AZ DEPARTMENT OF WATER RESOURCES WELL REGISTRY REPORT - WELLS55

Location D 14.0 14.0 35 A D C Well Reg.No 55 - 216837 AMA TUCSON AMA

RE: Notice of Intention to Replace an Existing Non-Exempt Well
Registration No. 55-216837(Replacing Well No. 55-621582); File No. D(14-14)35ADC

TO: Danita Haywood, Phoenix AMA
Linda Ingraham, Tucson AMA
FROM: Seandale Poes 
Water Quality Unit
DATE: November 20, 2007
SUBJECT: Notice of Intent to Replace a Well in an AMA
Well 55-216837
Davis Monthan Air Force Base

FIGURE 1 for DWR 55-90 section 8. SCHEMATIC DIAGRAM OF WELL CONSTRUCTION FOR PRODUCTION WELL #2B, DAVIS-MONTHAN AIR FORCE BASE

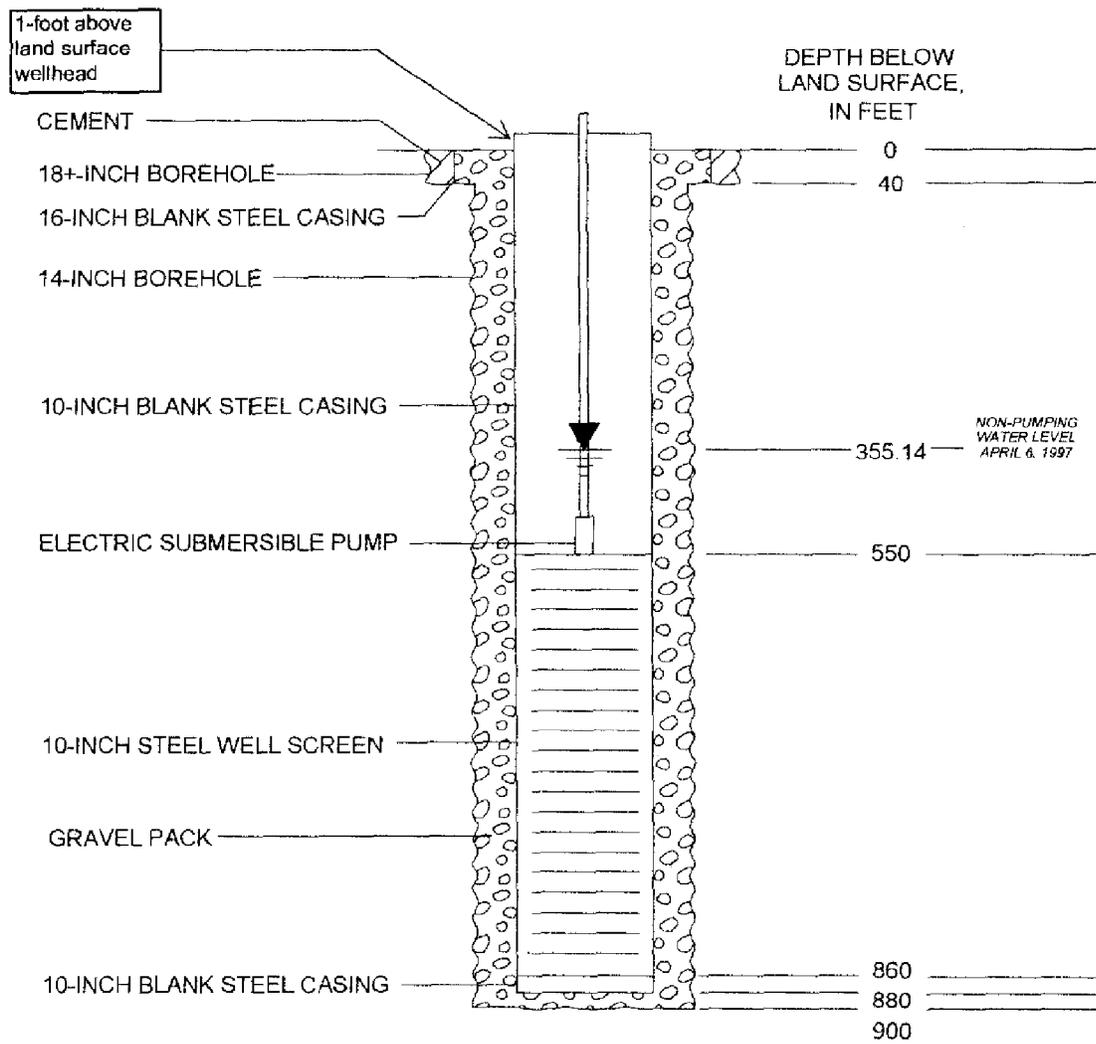
Hydrology has reviewed the above referenced notice of intent to replace a well for water quality concerns and well construction for conformance to Arizona well construction standards.

FIGURE 1 for DWR 55-90 section 8. SCHEMATIC DIAGRAM OF WELL CONSTRUCTION FOR PRODUCTION WELL #2B, DAVIS-MONTHAN AIR FORCE BASE

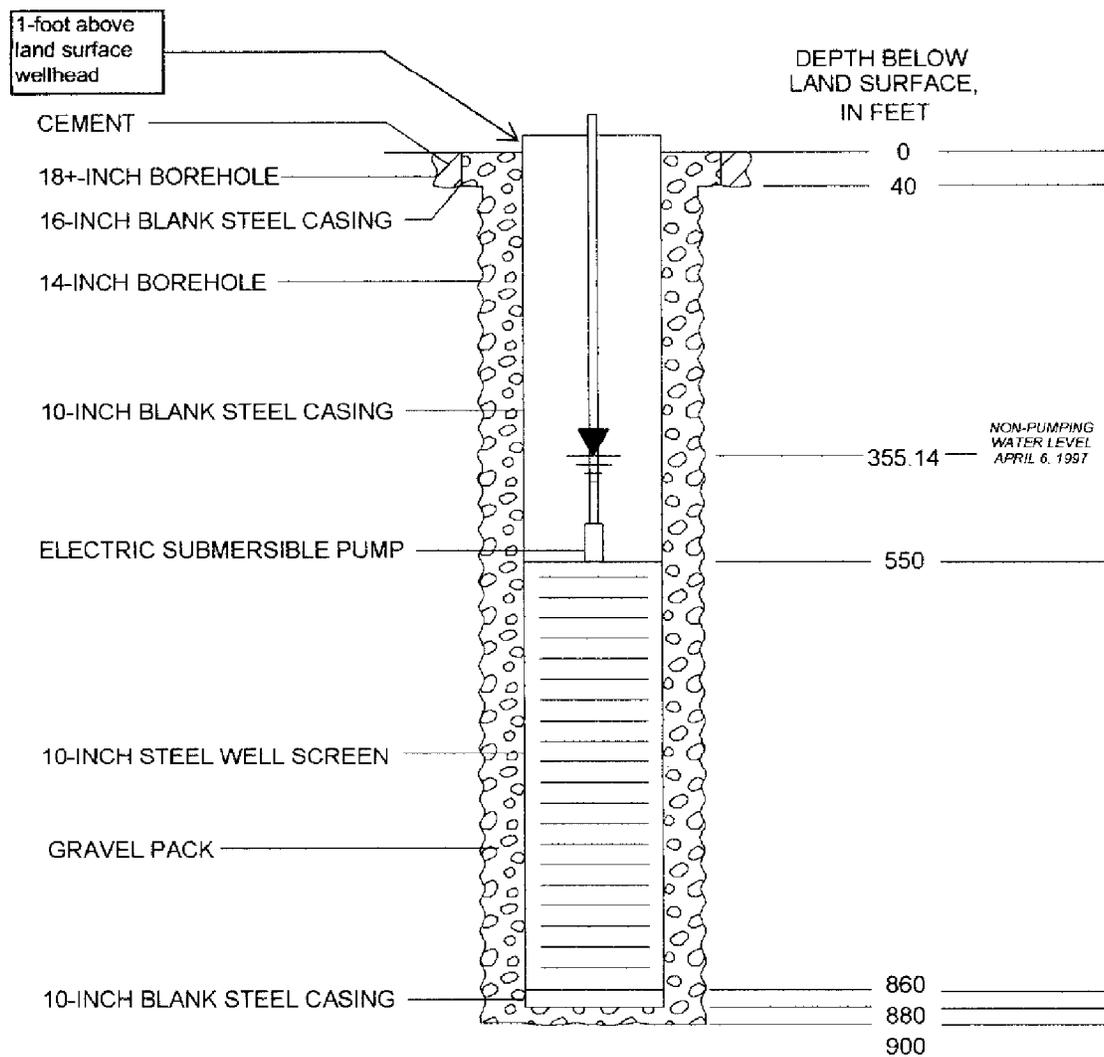
Hydrology has reviewed the above referenced notice of intent to replace a well for water quality concerns and well construction for conformance to Arizona well construction standards.

3. The well will be drilled to 900 feet below the land surface and screened from 550 to 860 feet. The well will be completed in the middle alluvial unit. The wells meet minimum well construction standards. No special well construction requirements are necessary.

The Hydrology Water Quality Unit has no objections to approving this permit. If additional information is needed, please contact me at extension 1-8565.
